INDESIT company

Model type:
IDE100SIT

Commercial code:
F030216

N1045072FIG1

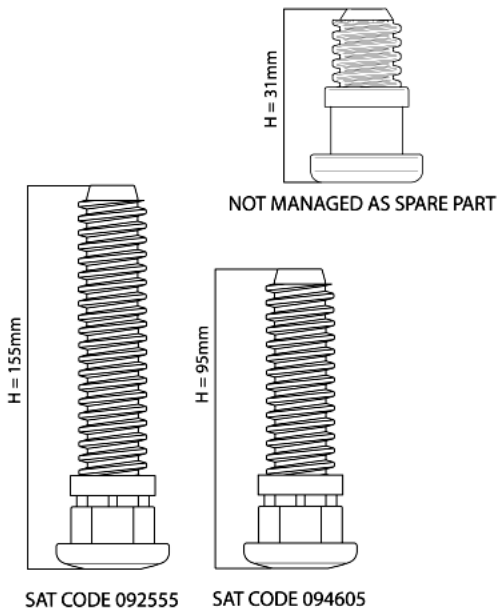
N1045072: Introduction of fixed rear foot H=31mm on free-standing models.

From serial no. 40218.0001, free-standing dishwashers affected by this modification have been equipped with new fixed rear feet (H=31mm).
The new foot replaces the adjustable one (H=155mm) Service code 092555; on the EVO3 range with TurboDry the new foot replaces the adjustable foot (H=95mm) Service code 094605.
The Spare Part Warehouse will continue to manage only 155mm and 95mm adjustable feet as they are interchangeable with the fixed 31mm foot.
The three feet are shown in illustration N1045072FIG1.

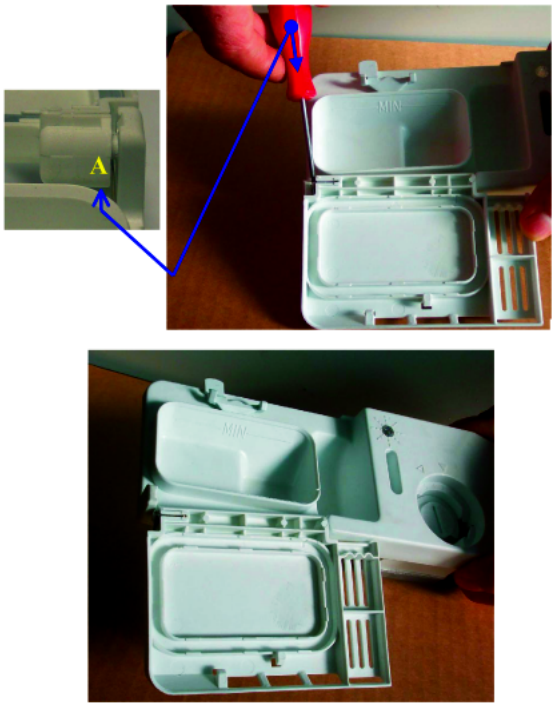
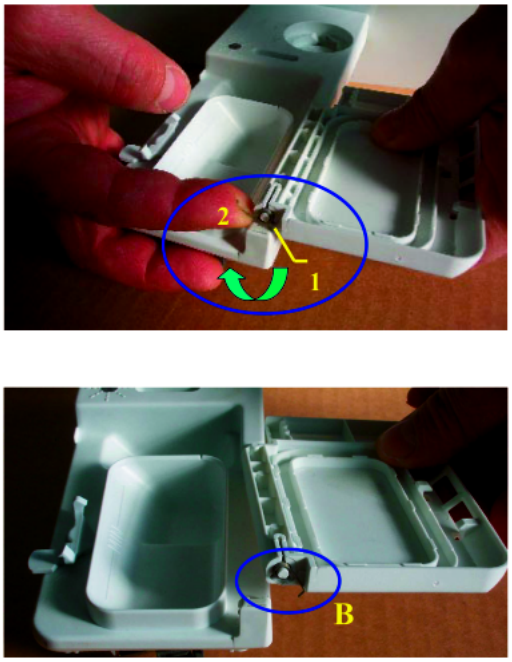
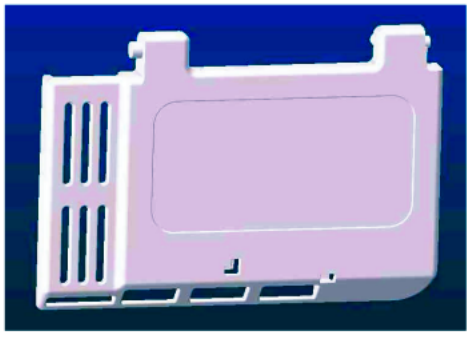
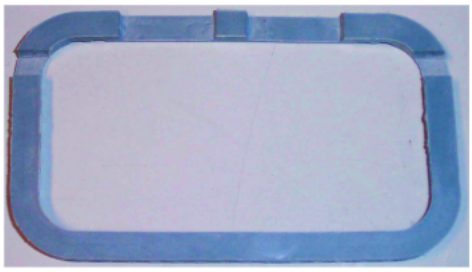
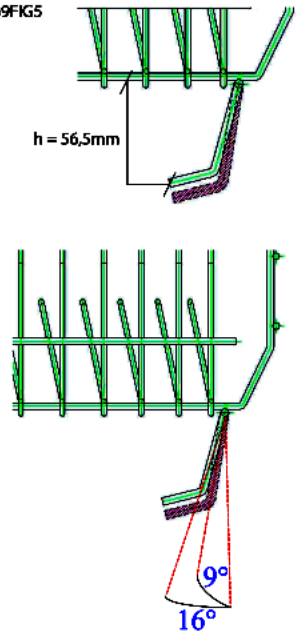
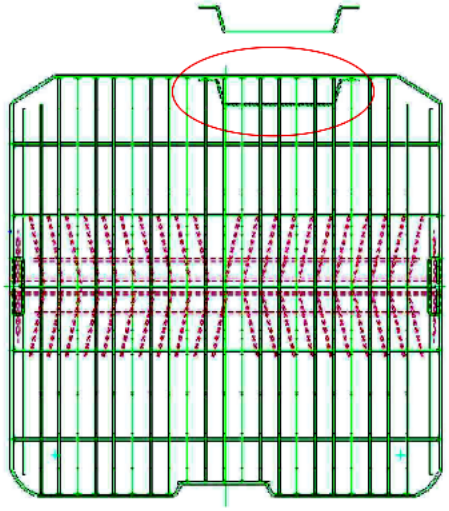
n1045069: Modification of racks and dispenser lid on EVO3 dishwashers

To obtain better dissolving of the detergent during the wash cycle, the following modifications have been made to EVO3 dishwashers:
- new dispenser lid, replacement code 098134 (see figure N1045069FIG4) created;
- upper racks modified with lid catch angle changed from 9° to 16° (see figure N1045069FIG5);
- MultiSystem lower racks modified with insertion of a spacer wire at the electric dispenser (see figure N1045069FIG6).

Lid installation instructions:
1) prise the lid out of the dispenser seat using a small screwdriver at point A (figure N1045069FIG1);
2) replace the lid, checking that release spring B (figure N1045069FIG2) is in place; before fitting the new lid load the spring from position 1 to position 2 (figure N1045069FIG2);
3) fit the lid in its special seat and check for correct operation (figure N1045069FIG3).
Lid closing may be harder for the first few cycles after replacement, due to settling of the material.

The upper and lower racks have the same spare part codes as the premodification items; Replacements Warehouse stocks have been replaced.

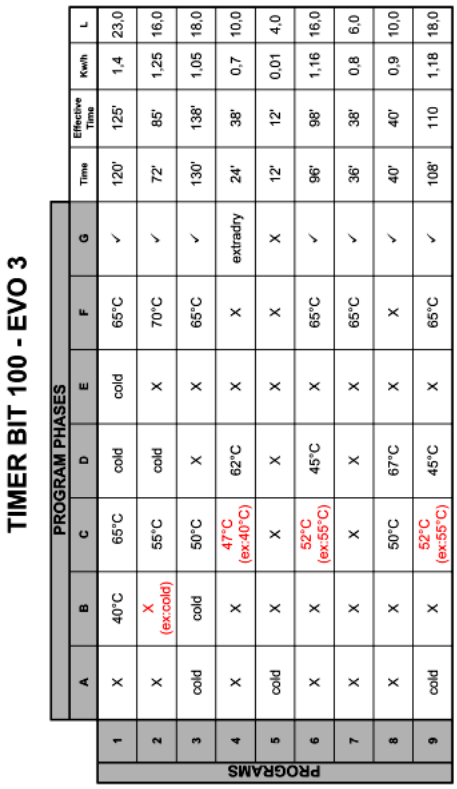
n1045082: Timer Bit 100 programmes for Evo3 60cm dishwashers

Table N1045082FIG1 shows information relevant to the programmes of the following Timer Bit 100 for Evo 3 60 cm dishwashers:
Timer BIT 100 - E1 - Service code 097890 (rohs 143206);
Timer BIT 100 - E2 - Service code 097481 (rohs 143207);
Timer BIT 100 - E3 - Service code 099892 (rohs 143208);
Timer BIT 100 - S1 - Service code 109875 (rohs 143211).

PROGRAMME MODIFICATIONS ARE INDICATED IN RED.

PROGRAMS	PROGRAM PHASES							Time	Effective Time	Kwh	L
	A	B	C	D	E	F	G				
1	X	40°C	65°C	cold	cold	65°C	✓	120'	125'	1,4	23,0
2	X	X (ex:cold)	55°C	cold	X	70°C	✓	72'	85'	1,25	16,0
3	cold	cold	50°C	X	X	65°C	✓	130'	138'	1,05	18,0
4	X	X	47°C (ex:40°C)	62°C	X	X	extradry	24'	38'	0,7	10,0
5	cold	X	X	X	X	X	X	12'	12'	0,01	4,0
6	X	X	52°C (ex:55°C)	45°C	X	65°C	✓	96'	98'	1,16	16,0
7	X	X	X	X	X	65°C	✓	36'	38'	0,8	6,0
8	X	X	50°C	67°C	X	X	✓	40'	40'	0,9	10,0
9	cold	X	52°C (ex:55°C)	45°C	X	65°C	✓	108'	110	1,18	18,0

N1045083FIG1

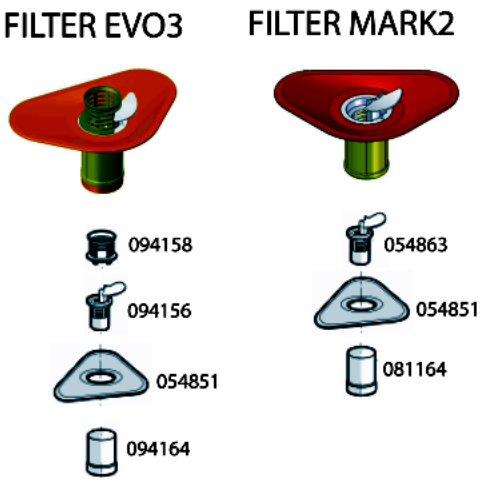
n1045083: Modification of filters on EVO3 60 cm dishwashers

All dishwasher models affected by this modification have been equipped with the items listed below, in order to solve the drain pump clooging problem.

Introduction of:
Cylindrical plastic filter code 081164
Central filter code 054863

Elimination of:
Cylindrical plastic filter code 094164
Central filter code 094156
Central filter grid code 094158

The modification has been introduced progressively, starting from serial no. 40516.0001.

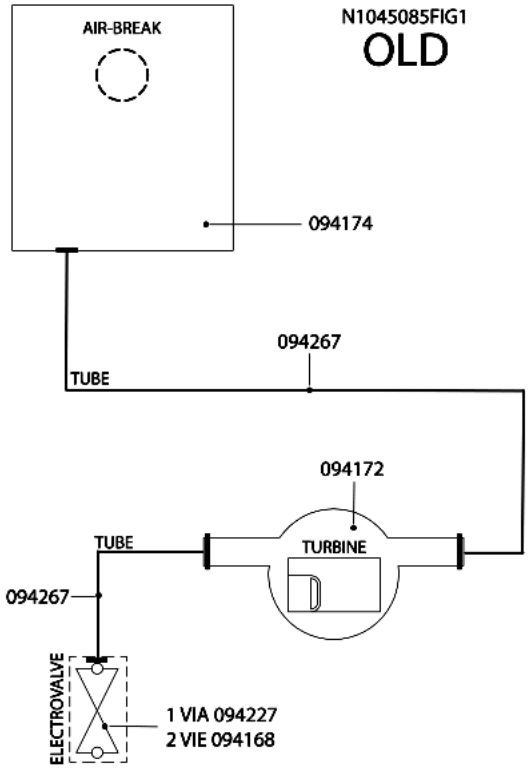
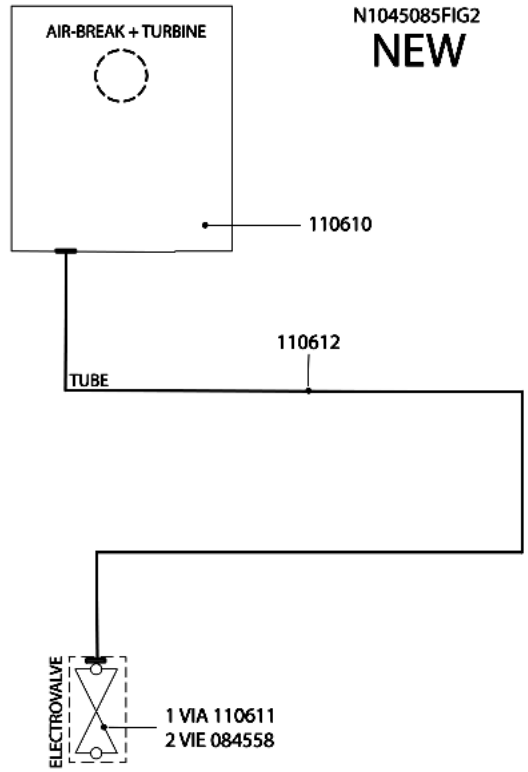
n1045085: Introduction of new litre counter turbine integrated on air-break.

All dishwashers affected by this note have been equipped with a new litre counter turbine on the air-break.
Picture N1045085FIG1 illustrates the premodification structure, picture N1045085FIG2 the new structure.

AIR-BREAK:
new 110610;

premodification 094174;
the new item features a new integrated litre counter turbine and its water supply hose has a smaller diameter.

LITRE COUNTER TURBINE code 094172 has been eliminated.

SOLENOID VALVES:
new:
1-WAY code 110611;
2-WAY code 084558(Rohs 143737);
premodification:
1-WAY code 094227;
2-WAY code 094168;
the new solenoid valves have a smaller diameter drain hose fitting.

HOSES:
new solenoid valve hose/air-break code 110612;
premodification turbine hose/air-break code 094267;
premodification solenoid valve hose/air-break code 094267;
the new hose has a smaller internal diameter.

WIRING:
the litre counter turbine connecting cable is longer, but since the connector is the same, the new item can be used in place of the premodification one.
